HISTORIC DISTRICT COMMISSION

NOTICE OF DENIAL

Application Number: HDC2025-00729

NAME: Peter Markaj		COMPANY NAME: N/A	
ADDRESS: 2050 Atkinson	CITY: Detroit, Michigan 48206	STATE: MI	ZIP: 48206
PROJECT ADDRESS: 2050 Atkinson			
HISTORIC DISTRICT: Atkinson Avenue			
SCOPE: Remaining work items.

W/ SECURITY
DOOR

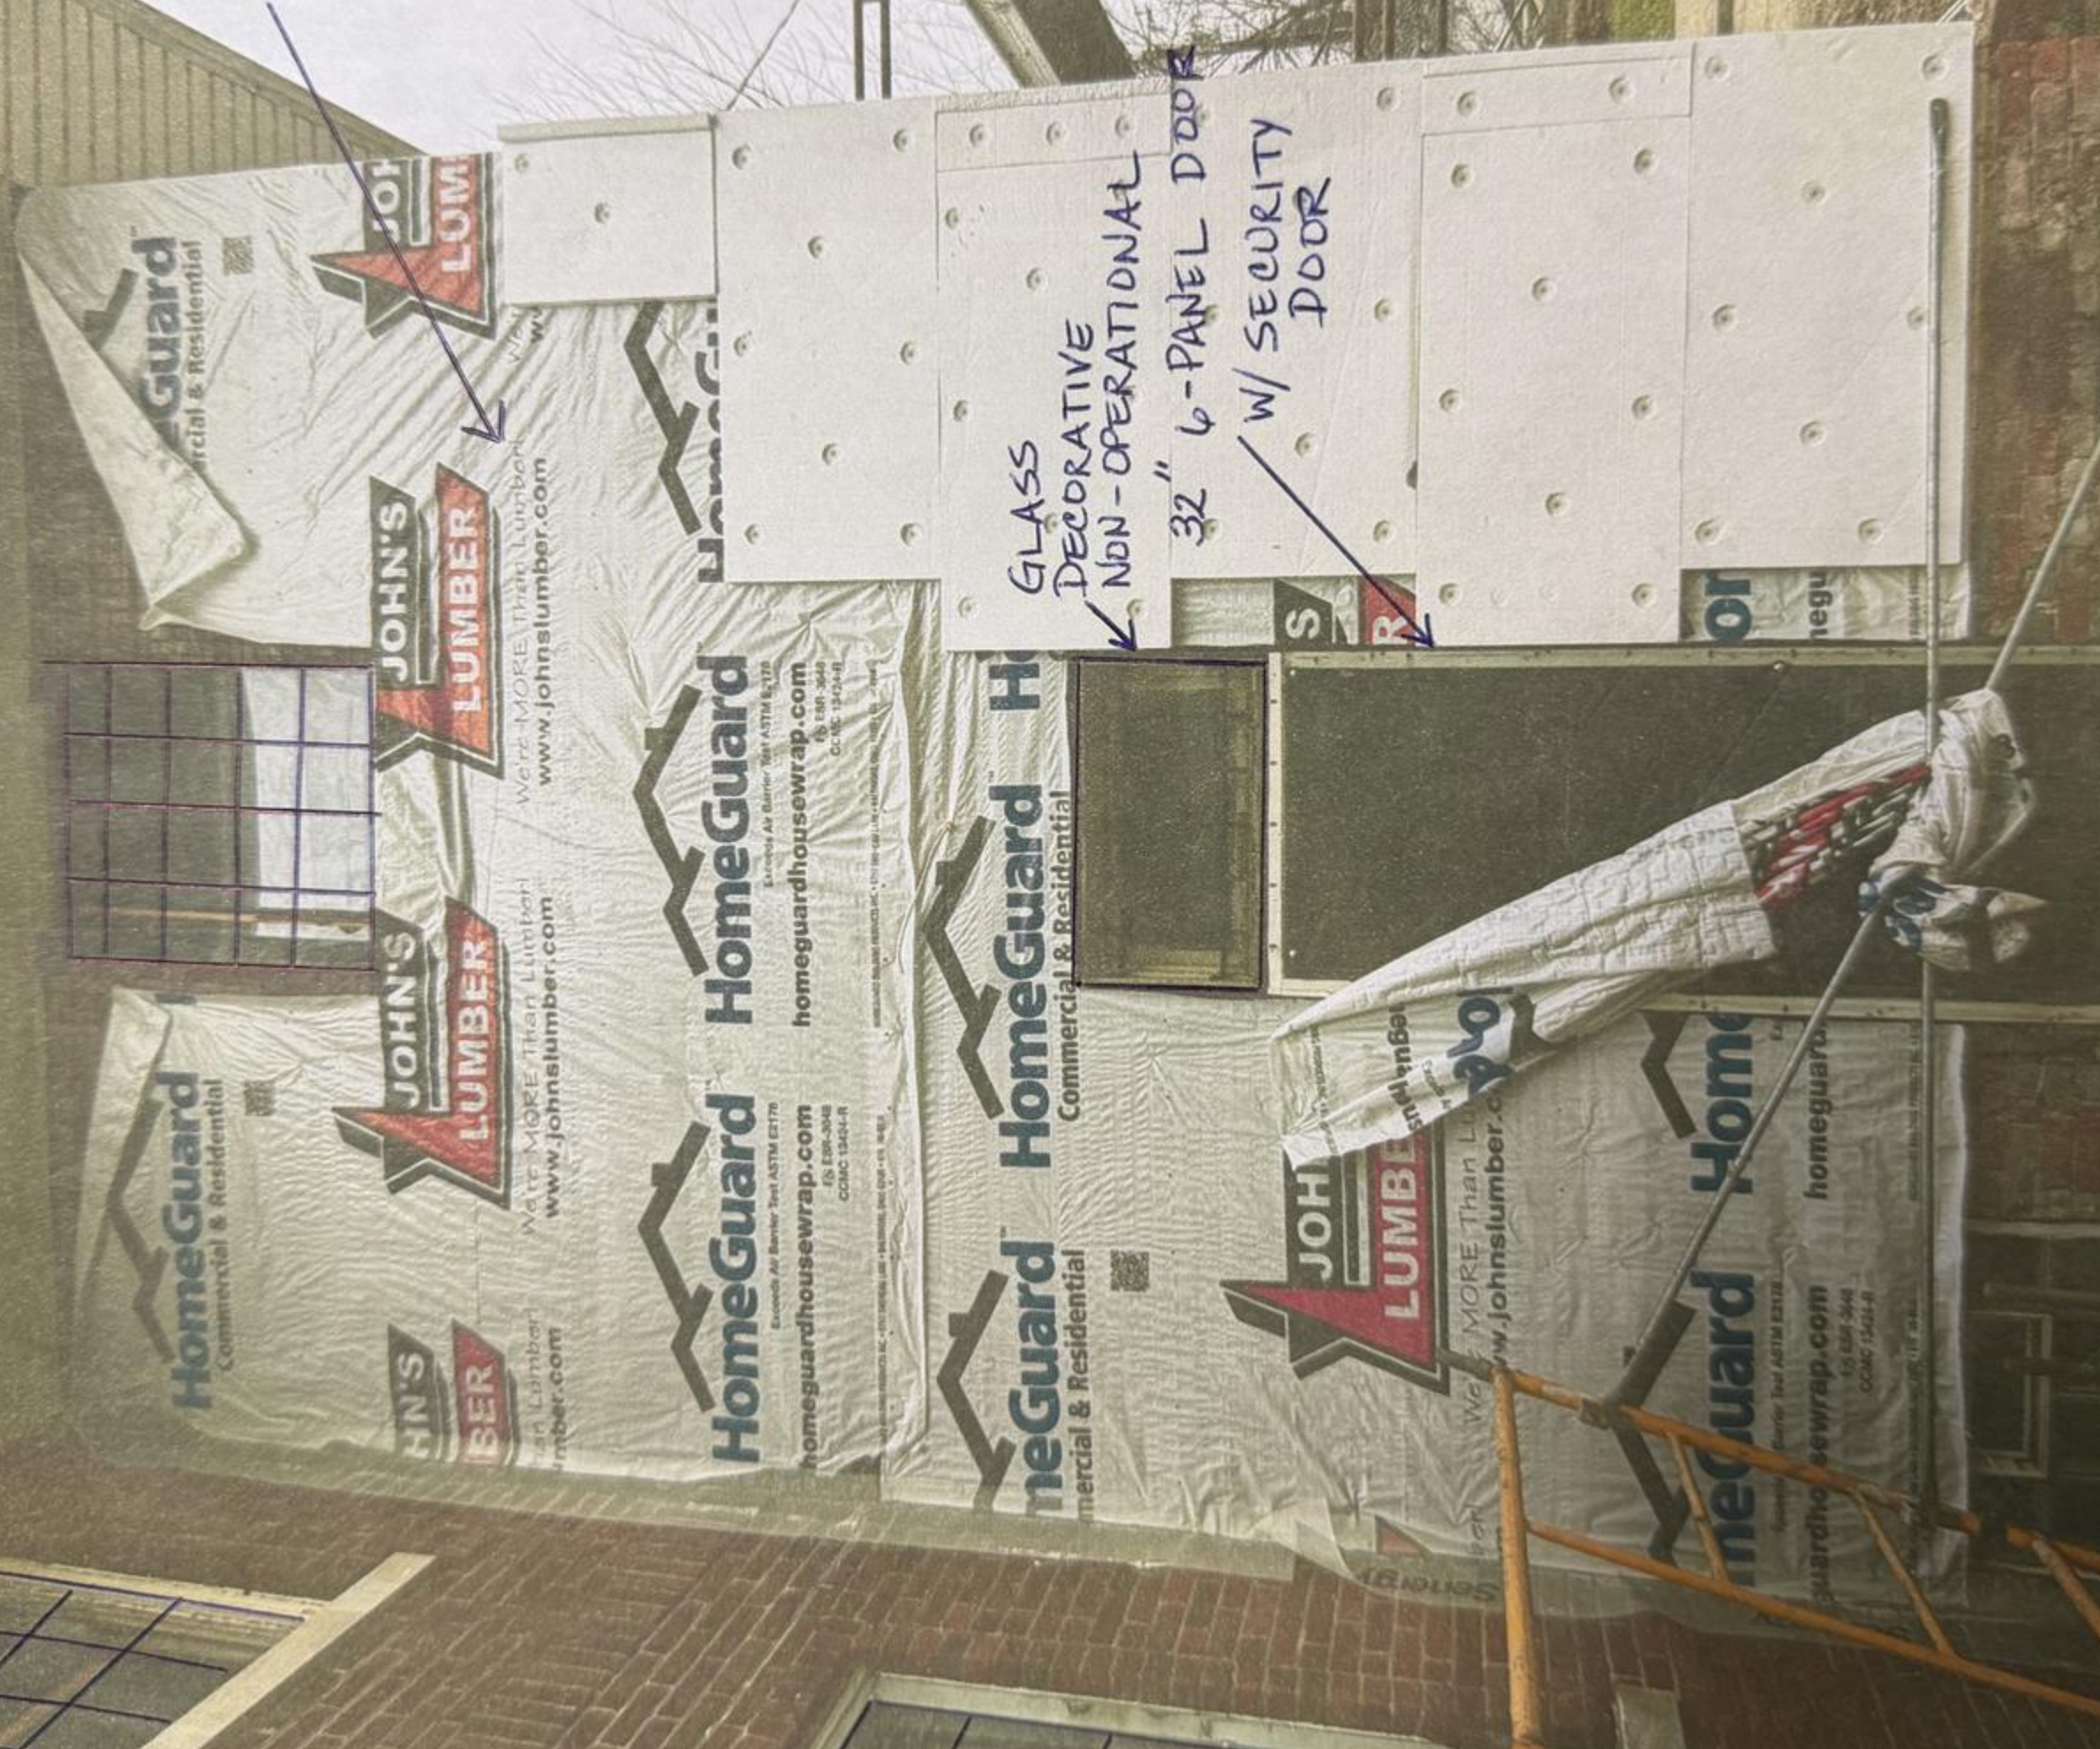
The pattern drawn in the windows give the effect of casement windows, not double-hung sash, as there is no identified central/thicker meeting rail. The one double-hung window already installed on the side (west) wall has a six-over-six pattern; however, the drawn in windows, if double-hung, show a twelve-over-twelve pattern. Please confirm.

Please submit a dimensioned drawing to detail what is planned for above the entry. Are you building something or proposing to install a manufactured item?

Attached are the drawings for the proposed window installation with the same number of grids as on the front of the home and the others on other sides of the home are 4 and 4 grid patterns. The windows to be installed are manufactured by Pella Windows and were on site at time of purchase. All the windows are single hung and would match the ones already installed. Spec sheets have been requested from Pella to submitted upon receipt.

Above Entry Door - would be custom made and will be similar to ones in the area of same style and designs.
